## Addendum No. 1

**Project Number:** 23-153-01

**Project:** **Montana Fish, Wildlife, & Parks**  
Montana Outdoor Office Remodel  
930 Custer Avenue, Helena, Mt 59602

**1 NEW FLOOR PLAN**  
SCALE: 1/4" = 1'-0"

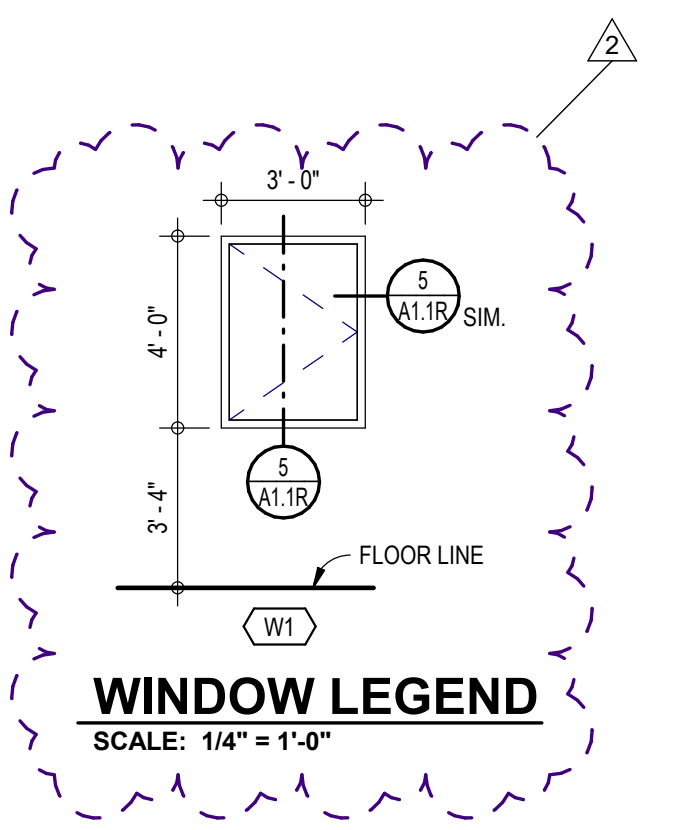
- ITEM A-4 SHEET A1.1R FIRST FLOOR PLAN:** Window legend references window type W1. Window tag has been added for reference. See re-issued architectural sheet A1.0R

- ITEM A-7 SHEET A1.1R FIRST FLOOR PLAN: Room Finish Schedule:** Office 105 & Office 106 will not receive new ceilings. See re-issued architectural sheet A1.0R

- ITEM A-8 SHEET A1.1R FIRST FLOOR PLAN: Room Finish Schedule:** Work Area/Storage 102 to receive new rubber base. See re-issued architectural sheet A1.0R

- ITEM A-9 SHEET A1.1R FIRST FLOOR PLAN: Room Finish Schedule:** Delete note at Entry 101 that references wall to receive level 1 texture on this side of wall. Replace with plan note #4. See re-issued architectural sheet A1.0R

- RELOCATED FIRE EXTINGUISHER
- PATCH AND REPAIR FURRING WALL AS REQ'D WERE ELECTRICAL BREAKER PANEL WAS REMOVED. MATCH ADJACENT FINISHES
- RELOCATED EXISTING CASEWORK, COORDINATE FIANL LOCATION THIS AREA W/ OWNER.
- THIS WALL SIDE ONLY TO RECEIVE LEVEL 5 FINISH FOR OWNER INSTALLED VINYL GRAPHICS

**5 WINDOW DETAIL**  
SCALE: 1 1/2" = 1'-0"

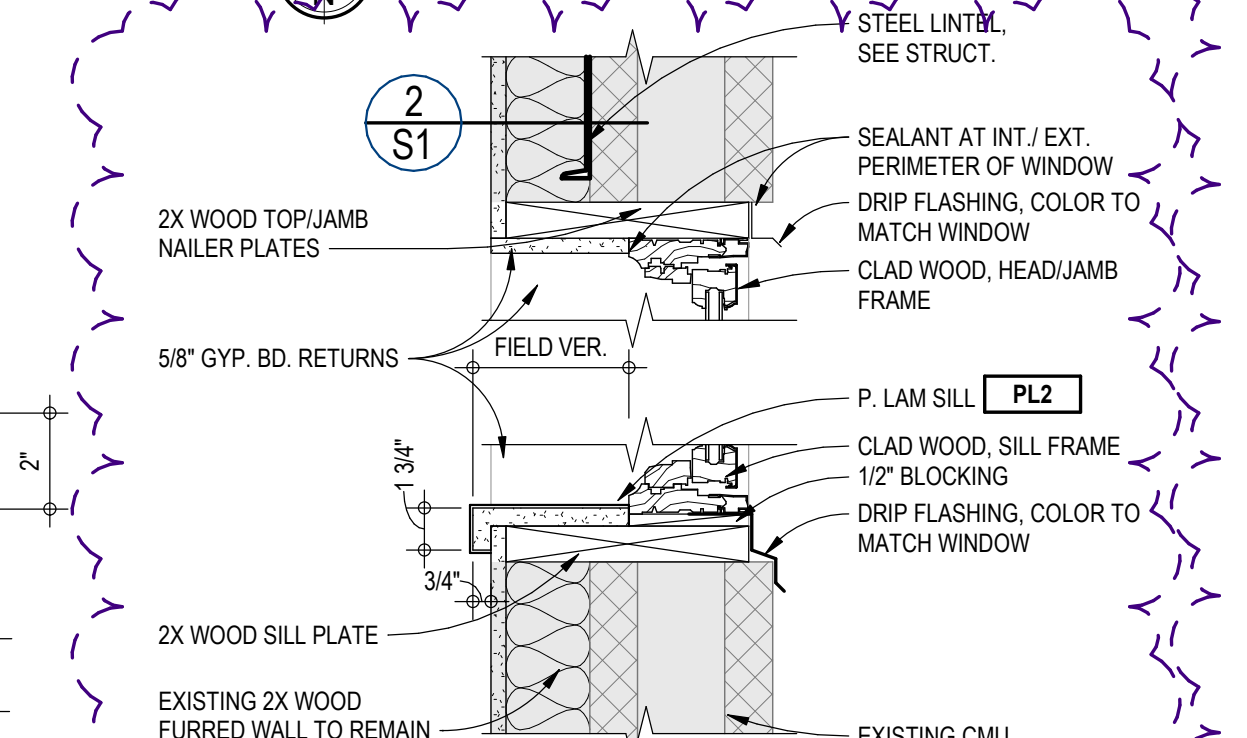
- ITEM A-6 SHEET A1.1R FIRST FLOOR PLAN: Detail #5 clarification:** Delete reference detail to 1/S1 and replace with 2/S1. See re-issued architectural sheet A1.0R

**TYPE MS WALL LEGEND**  
SCALE: 1" = 1'-0"

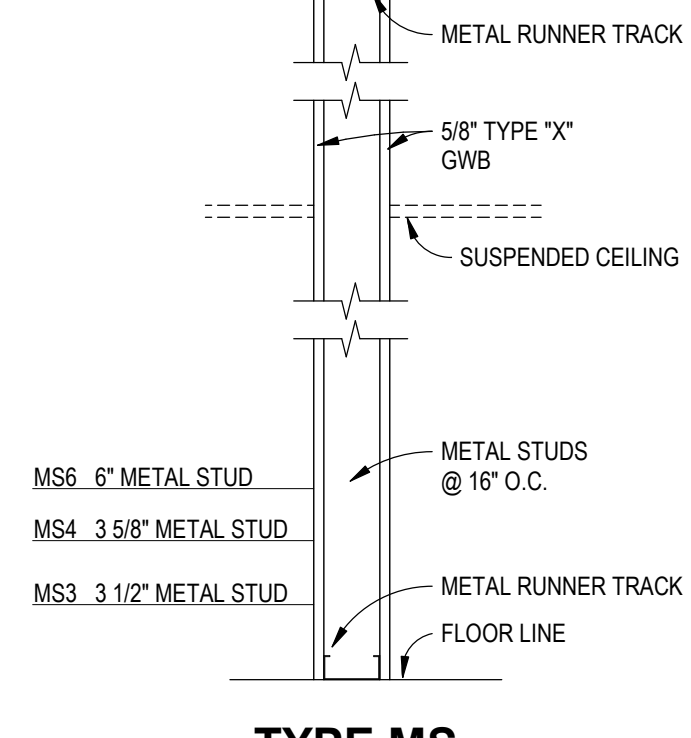
- ITEM A-5 SHEET A1.1R FIRST FLOOR PLAN: Wall Legend:** Wall type MS has been updated to reference wall types MS3 & MS6. See re-issued architectural sheet A1.0R

**3 EQUIP. CURB**  
SCALE: 1" = 1'-0"

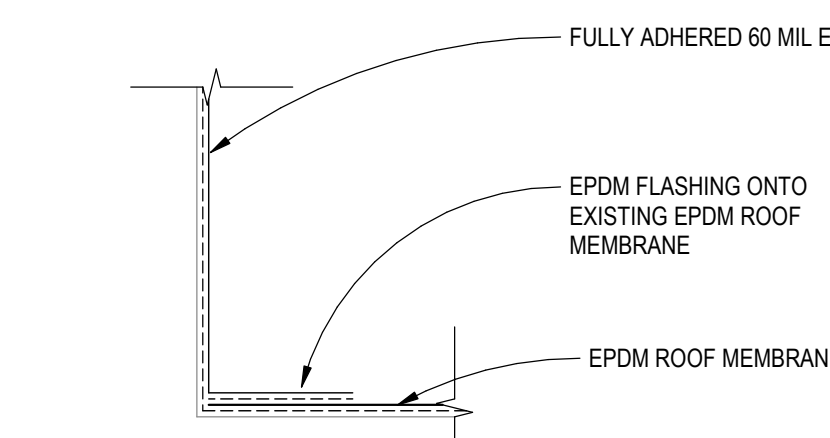
- ITEM A-11 SHEET A2.1R REFLECTED CEILING PLAN: Detail #3 clarification:** Per City review comment provide positive drainage around roof equipment. See re-issued architectural sheet A2.1R

**5 SOFFIT**  
SCALE: 1 1/2" = 1'-0"

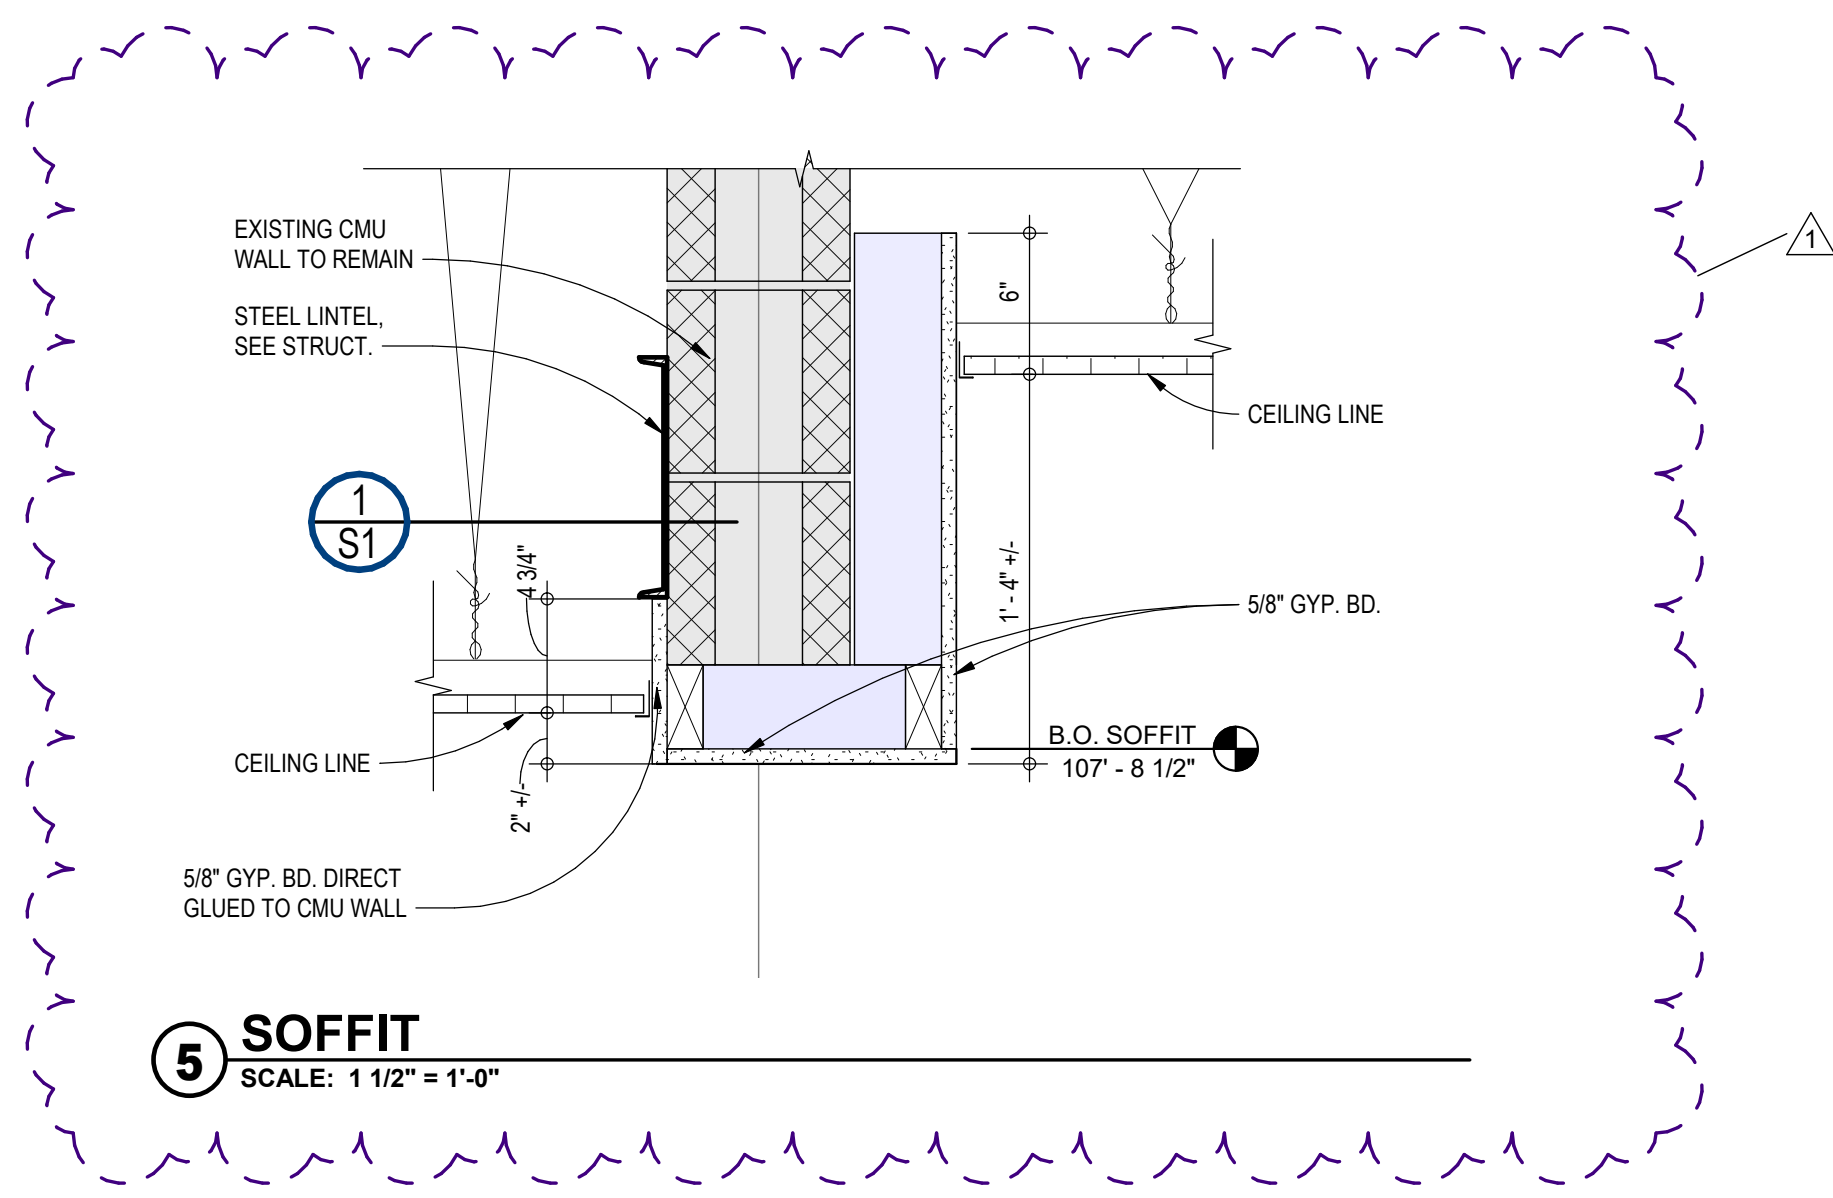
- ITEM A-10 SHEET A2.1R RELECTED CEILING PLAN Detail #5 clarification:** Delete reference detail to 2/S1 and replace with 1/S1. See re-issued architectural sheet A2.1R

**1 FIRST FLOOR - DEMO**  
SCALE: 1/4" = 1'-0"

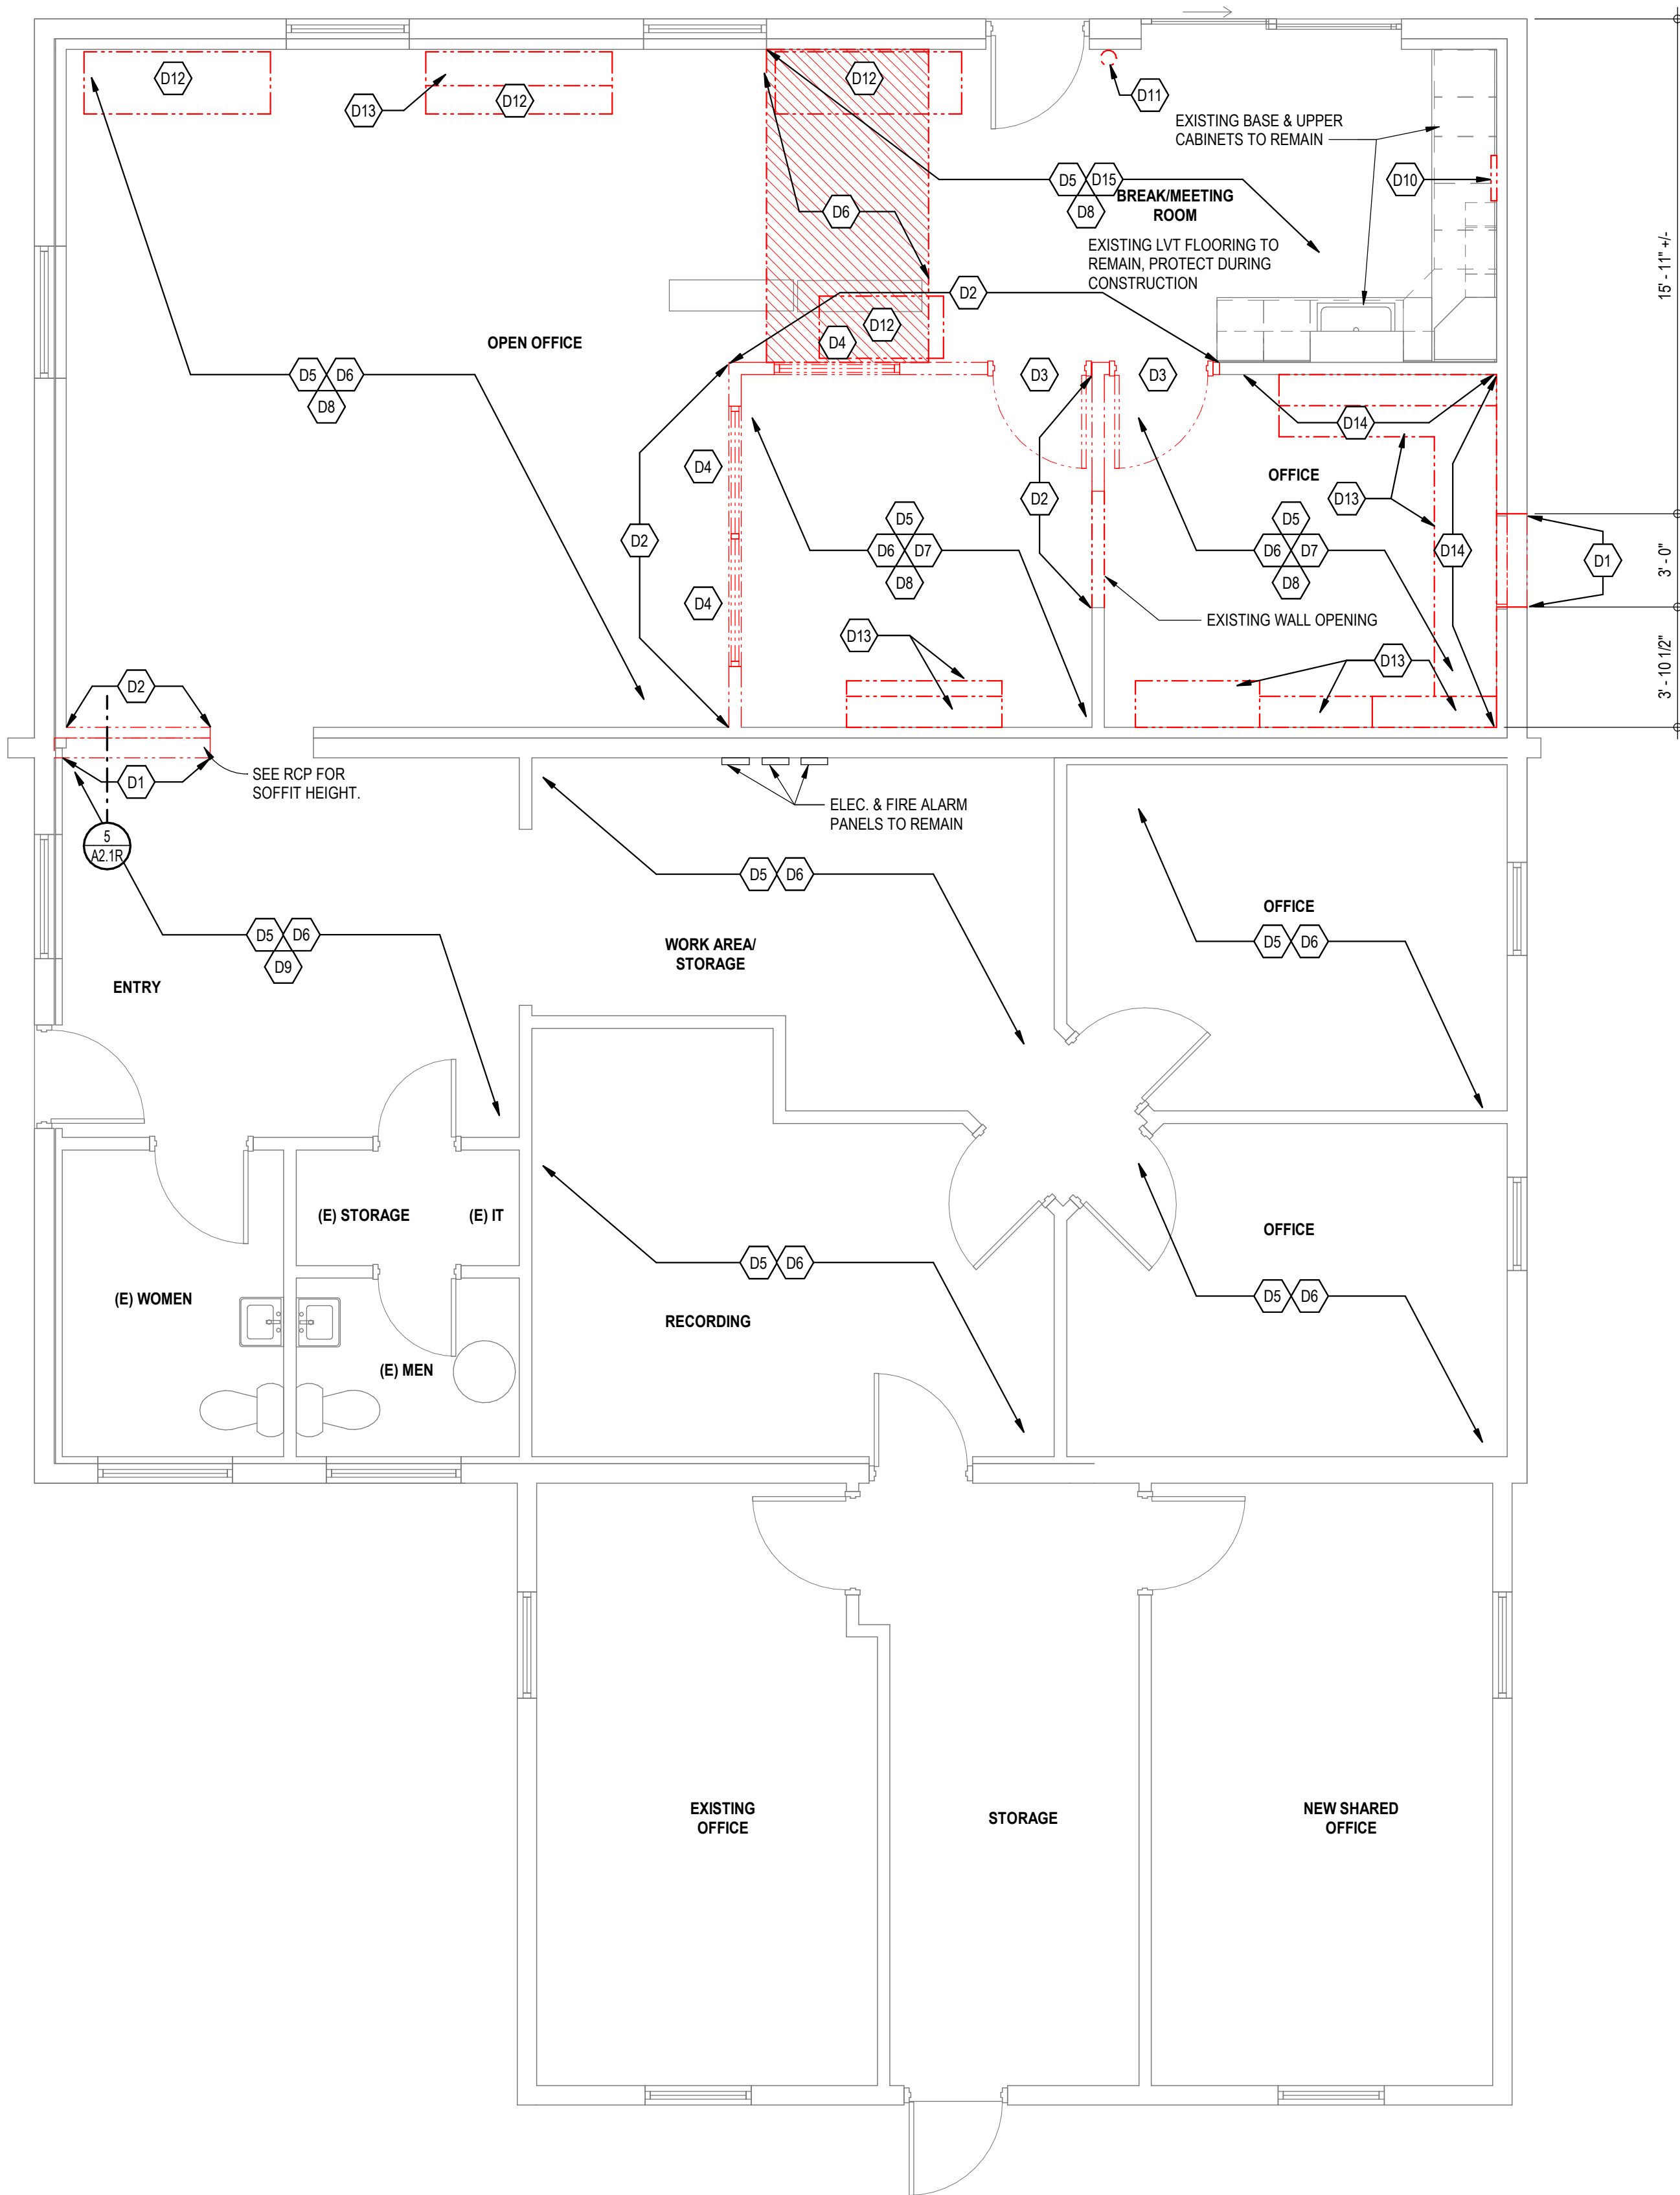
- ITEM A-1 SHEET AD1.0R DEMO – FLOOR PLAN:** (2) additional base cabinets to be relocated by contractor. Coordinate location with owner. See re-issued architectural sheet AD1.0R

- ITEM A-2 SHEET AD1.0R DEMO – FLOOR PLAN:** (1) additional upper cabinet to be removed completely on north wall of open office area. See re-issued architectural sheet AD1.0R

- ITEM A-3 SHEET AD1.0R DEMO – FLOOR PLAN:** Add demo plan note #D15 for extend of LVT removal in existing breakroom. See re-issued architectural sheet AD1.0R

- (D14) REMOVE EXISTING GYP. BD. TO 5'-0" A.F.F.
  - (D15) SELECTIVE REMOVAL OF EXISTING LVT FLOORING OUTSIDE OF BREAKROOM 104. SEE NEW FLOOR PLAN ON A1.1 FOR EXTENT OF LVT TO REMAIN. PROTECT LVT FLOORING DURING CONSTRUCTION.
